Application Number:	PL/2026/02472
Location:	Land Rear of 117, High Street, Dilton Marsh
Proposal:	Reserved Matters Application for Landscaping, Appearance, Layout and Scale for 54 dwellings following outline planning permission PL/2023/01880 approved at appeal (APP/Y3940/W/24/3352160)

Introduction and Proposal

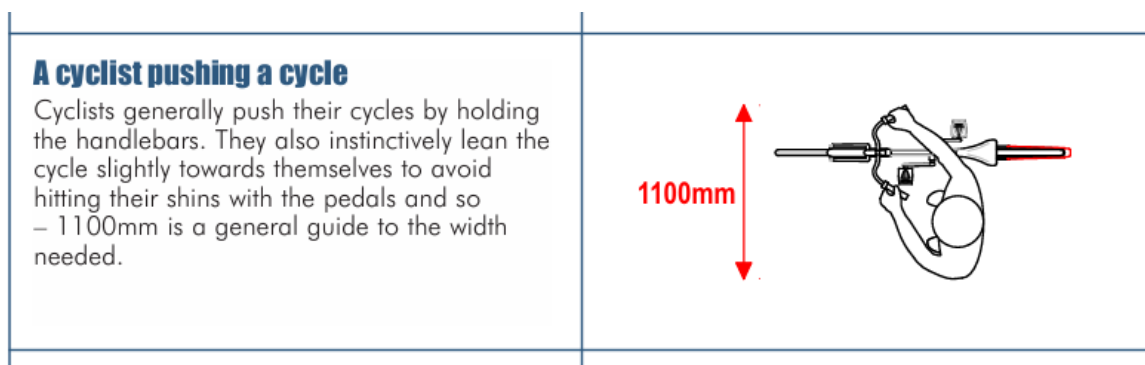
Parking for Plots 29, 31 and 32 – the second space is located within the rear garden area and separated by a footpath. This could potentially result in the footpath being obstructed by overhanging vehicles, particularly with the length of the parking spaces being limited to 4.8m.

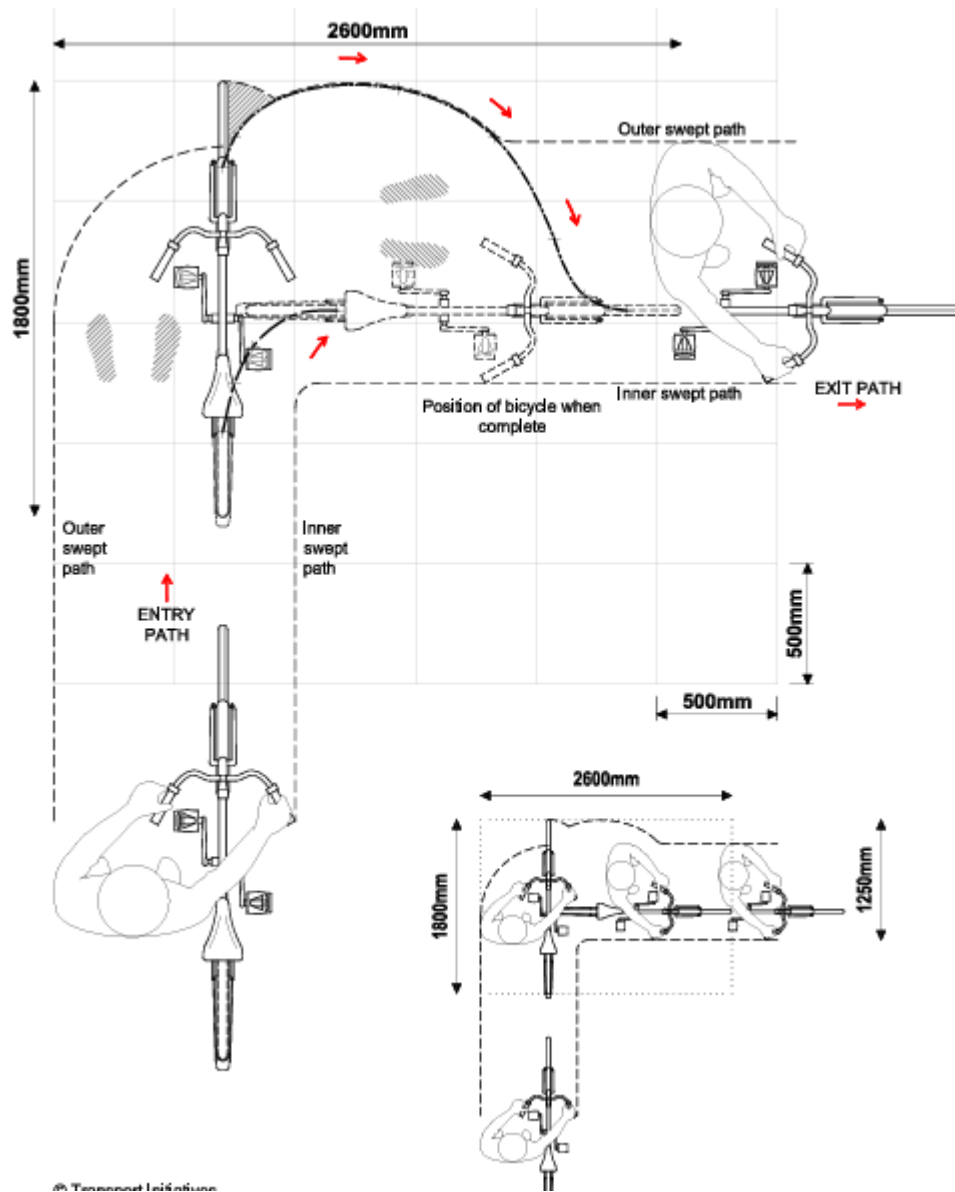
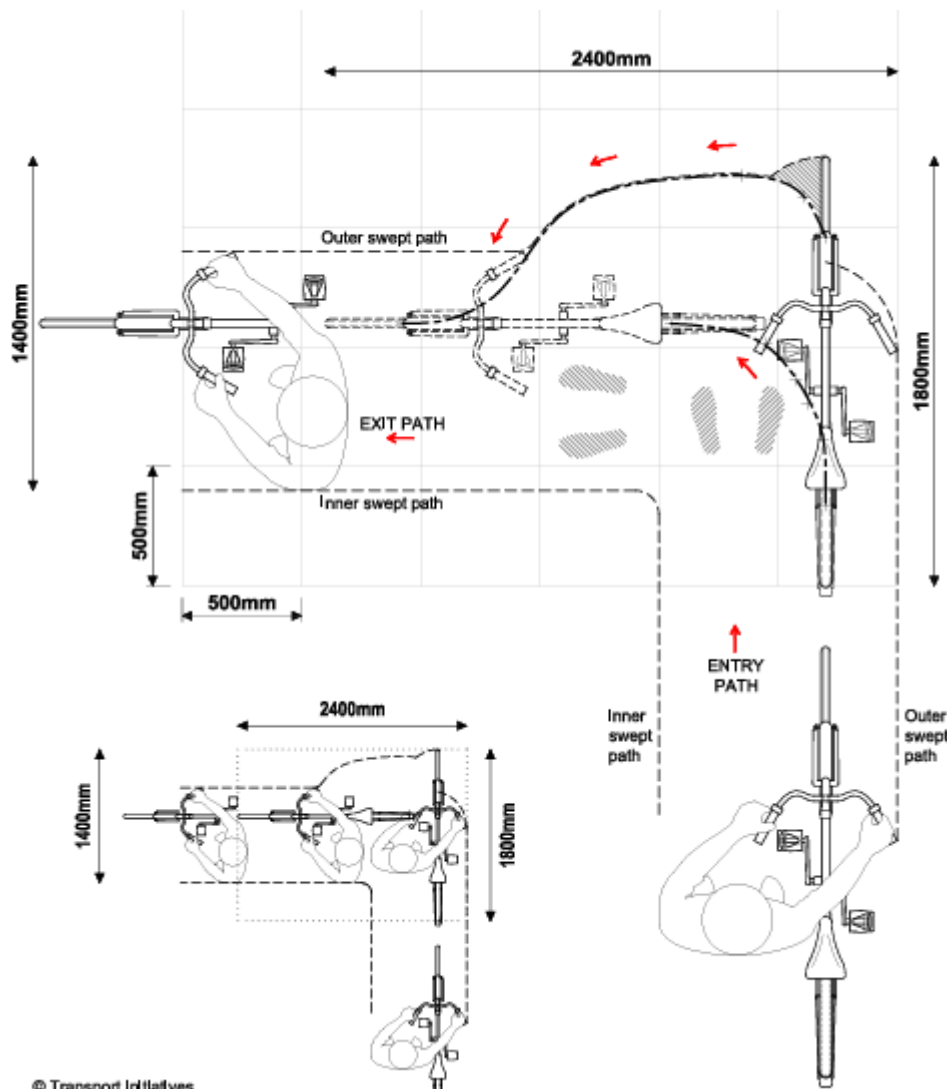
The cycle storage sheds for plots 18 and 19 are not appropriately located to provide ease of access to the rear garden gate, with the storage shed being located on the opposite side of the garden.

The access route to the cycle storage shed for Plots 44 and 45 is tortuous, and the limited width would make it difficult and potentially a disincentive to cyclists to use, contrary to sustainable travel. See details below of access requirements.
